**STAFF ANALYSIS**

**HIBERNIA DEVELOPMENT PLAN AMENDMENT**

**September 2, 2010**

Figure 4.3.3.1: Hibernia Drill Slot Assignments (Source: HMDG January 2010)

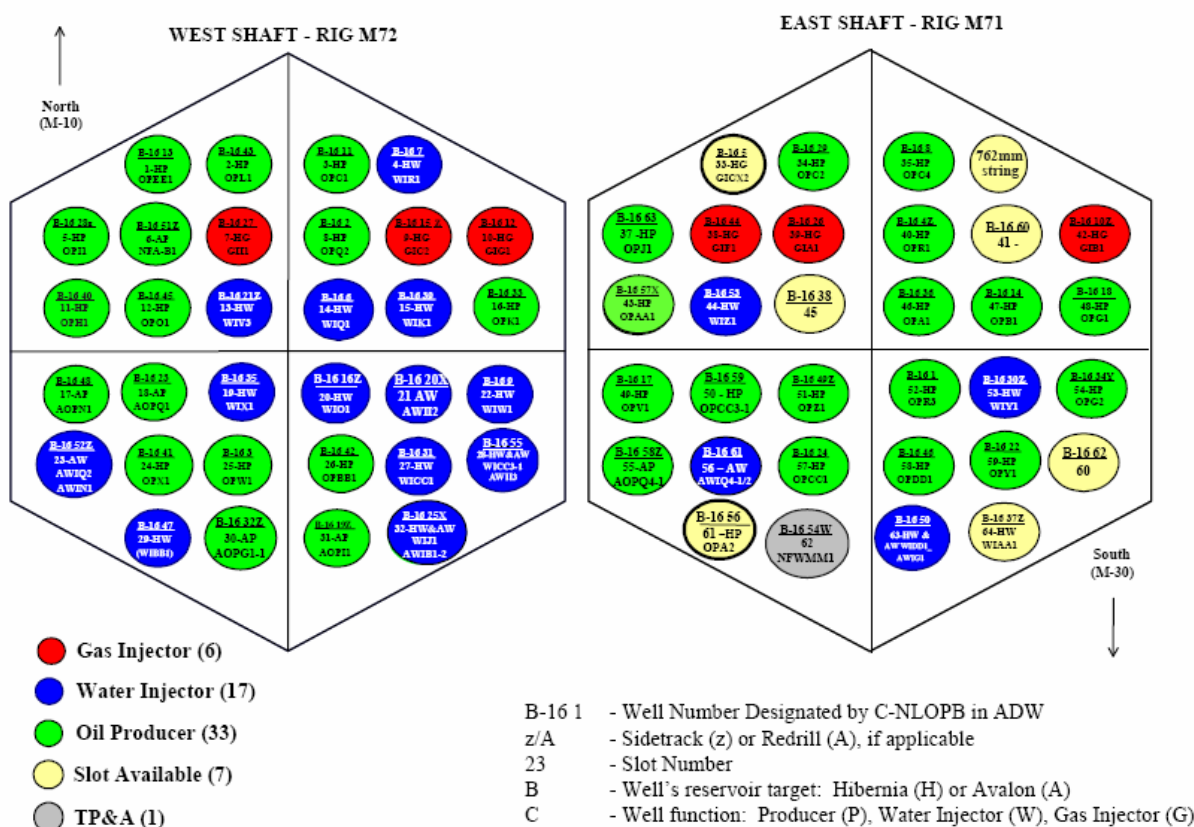
Figure 4.3.3.1 shows the November 2009 Hibernia GBS well slot configuration. The Proponent's plan is to utilize five slots to develop HSE Unit production wells along with a subsea template to develop the water injection wells. Based on the Proponent's drilling schedule (above), staff concludes that the HSE Unit development slot optimization strategy is reasonable.

Board staff reviewed *GBS Slot Additions Technical Feasibility Assessment* and *Hibernia Debottlenecking and Expansion Report*, both submitted as Part II supplemental documents to this Application, and agree with the Proponent's assessment that it is not feasible to add additional slots to the Hibernia Platform. Any further development opportunities will be dependent on reclaiming slots following the production life of developed wells, or through subsea development tied back to the platform through the existing J-tubes.

**Figure 4.3.4.1: Hibernia Full-Field Production Forecasts for Each Reservoir, Pool or Unit (Field Units) (Source: HMDC)**

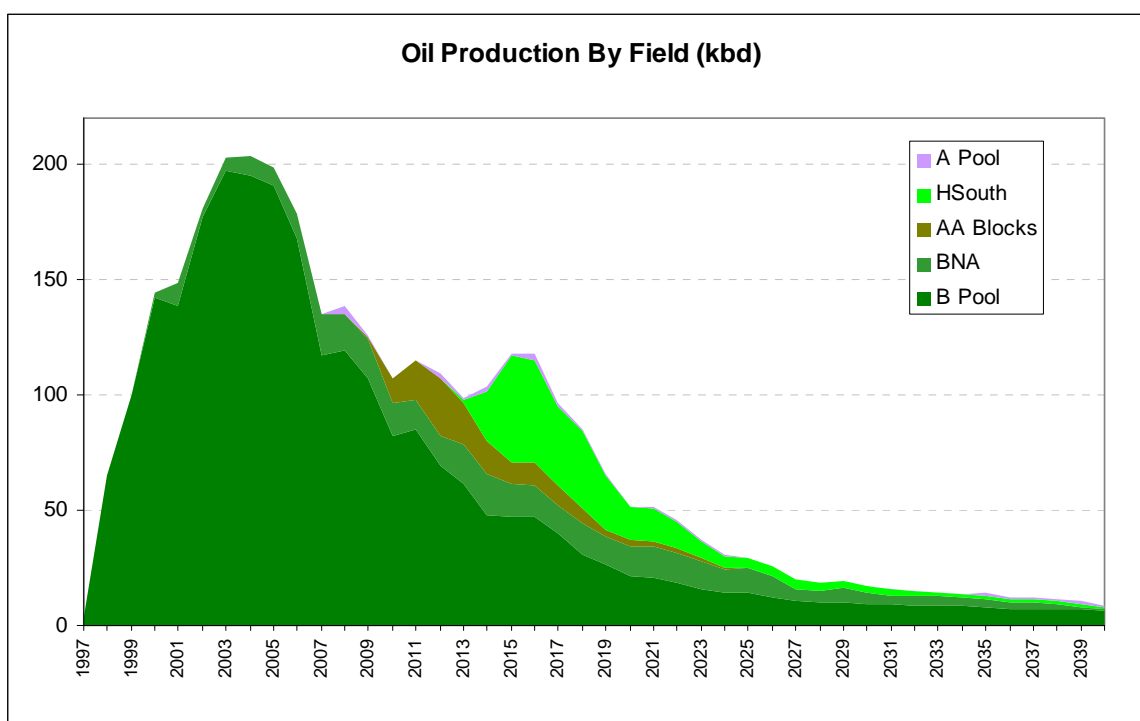
The Board's staff has reviewed the oil production forecasts provided by the Proponent (Figure 4.3.4.1). Several assumptions could affect the forecasts, including drilling schedule, criteria to determine when zones, pools and wells are shut-in, operational upsets and assumptions related to well slot availability.

The Proponent's production forecast for Hibernia Field appears reasonable. According to the Hibernia full-field forecast, the HSE Unit will provide the last significant peak of production (See figure 4.3.4.1) from the Hibernia Platform and will reach peak production in 2015, averaging 46,500 barrels per day, two years following initial production in 2013.

**Figure 4.3.5.1: Hibernia Oil Production Forecast with Economic Limits (Thousands of Barrels per Day) (Source: HMDC)**

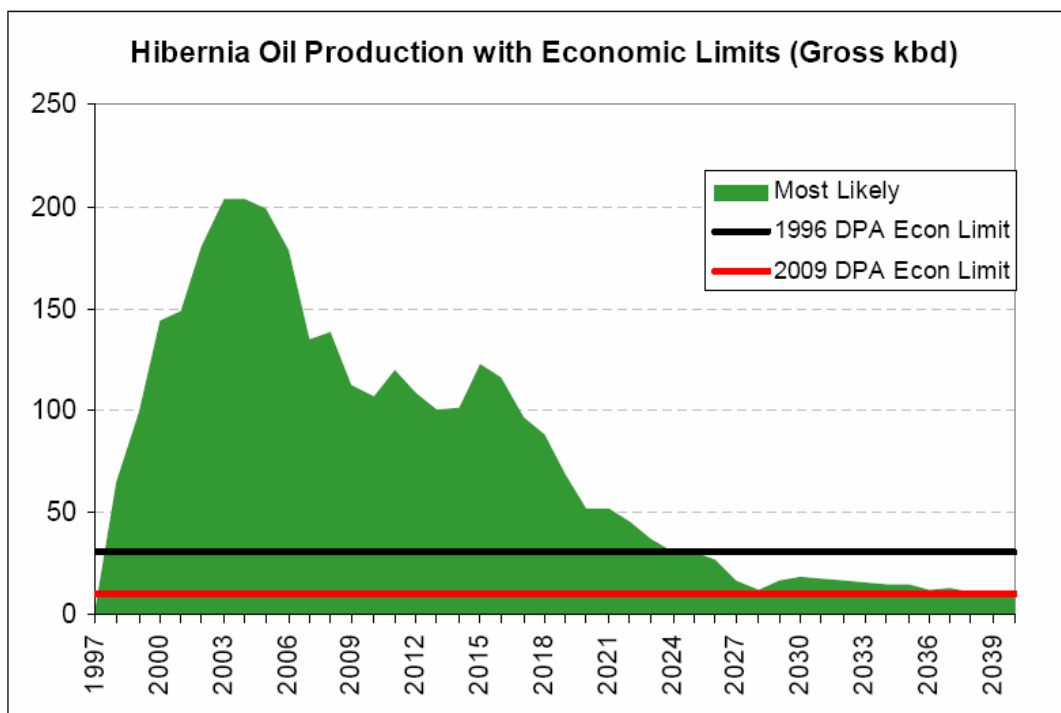
In the Decision Report 97.01, the Proponent had a field economic cut-off of 31,500 barrels per day (5000 m<sup>3</sup> per day). This cut-off was based on 1994 estimates of capital and operating expenditures. This field economic cut-off was revised in the June 2009

DPA and lowered to 10,000 barrels per day (1590 m<sup>3</sup> per day) (Figure 4.3.5.1). This economic cut-off has been maintained in the current Application. Board staff agree that this is reasonable at this time.

Figure 4.3.7.1: Possible 2020 Gas Sales vs. Oil Production (Source: HMDC)

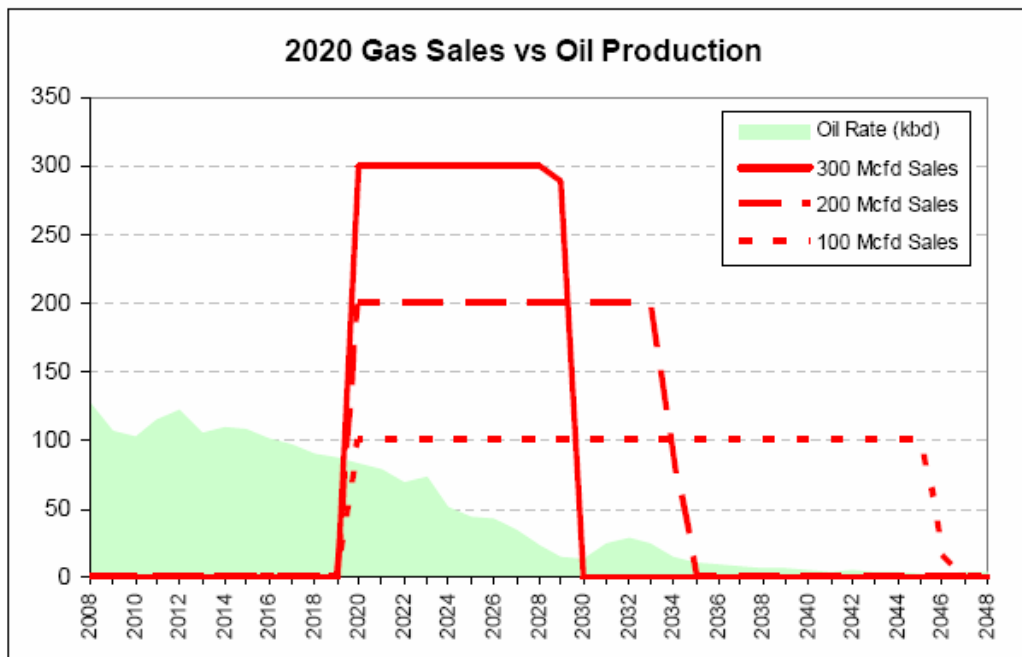
While the gas resource is currently used for fuel and for reservoir pressure support to exploit the oil reserves, it will eventually be available for production. Future exploitation of the gas resources may also extend the economic life of the Hibernia Field, permitting additional oil to be recovered. The Proponent conducted a preliminary review of gas commercialization in the Application. The timing of gas availability at the Hibernia Field for commercial purposes is dependent on the gas requirements for the exploitation of the oil reserves, and the natural gas liquids resources. According to the Proponent, Hibernia could support gas sales of 200-300 million standard cubic feet per day starting after 2020, in order to ensure that optimized reservoir oil exploitation occurs (Figure 4.3.7.1).

Board staff agrees with the Proponent that further technical assessment will be required to define the viability and timing of gas commercialization. The progress of the Proponent's gas commercialization plans will be assessed in the review of the Proponent's Annual Resource Management Plan.

**Figure A.3: Proposed HSE Unit Development Well Locations. (Source: HMDC)**

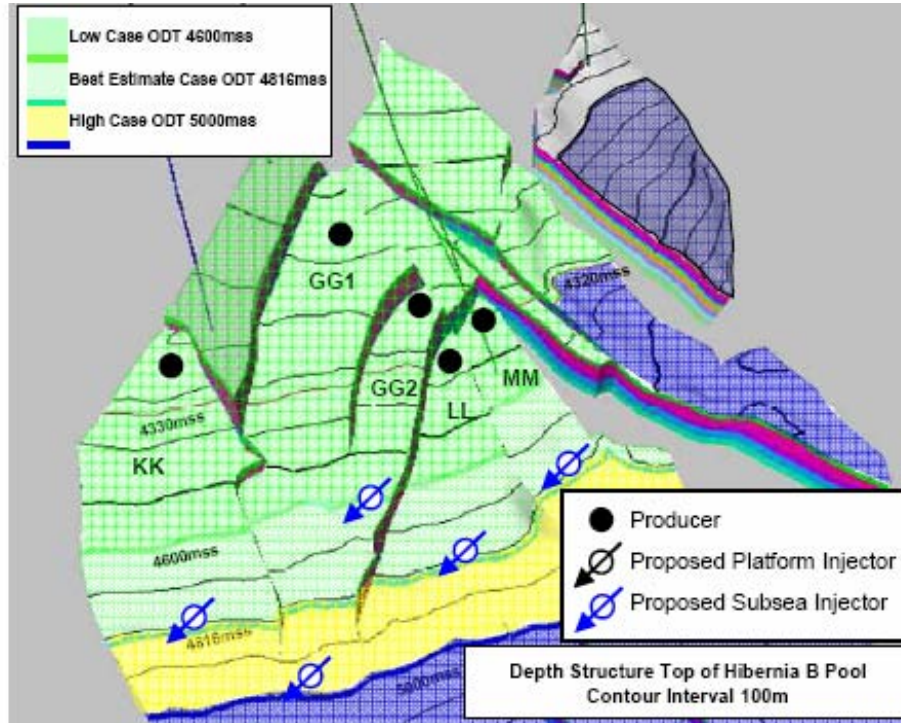
The Board's staff reviewed the Proponent's proposed depletion plan for the HSE Unit fault blocks (Figure A.3).

**Figure A.5: HSE Unit Oil Production Forecast.** (Source: C-NLOPB from HMDC)

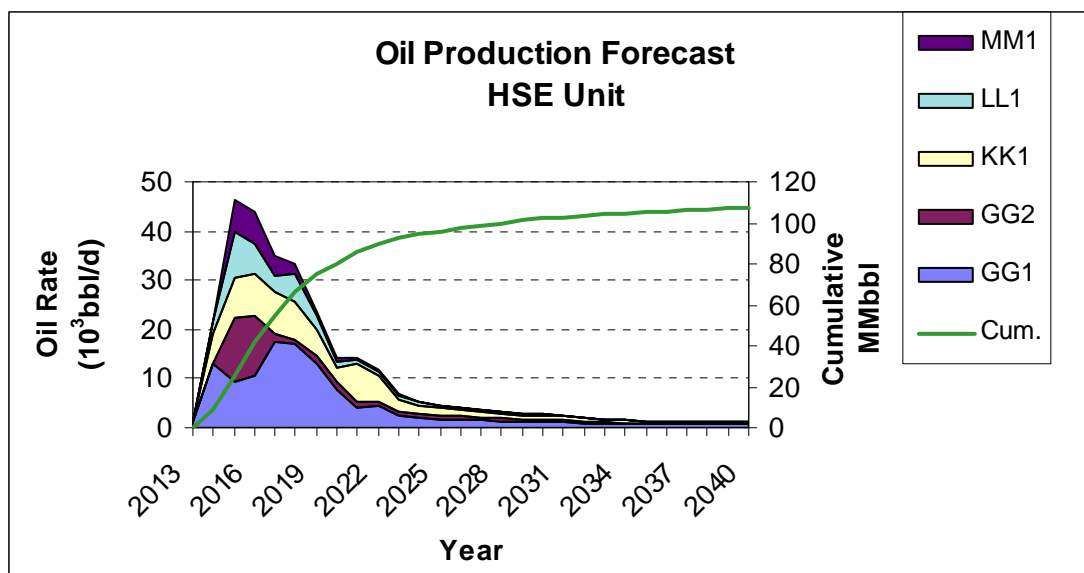
The Board's staff reviewed oil production forecasts provided by the Proponent for the HSE Unit. Figure A.5 shows that production will begin in 2013 from GG1 Block at an average of 1300 bbls/d in 2013, up to a maximum of 45,500 bbls/d when all blocks are online in 2015. Production is expected to last until 2040 with a cumulative production of 107.6 MMbbls.
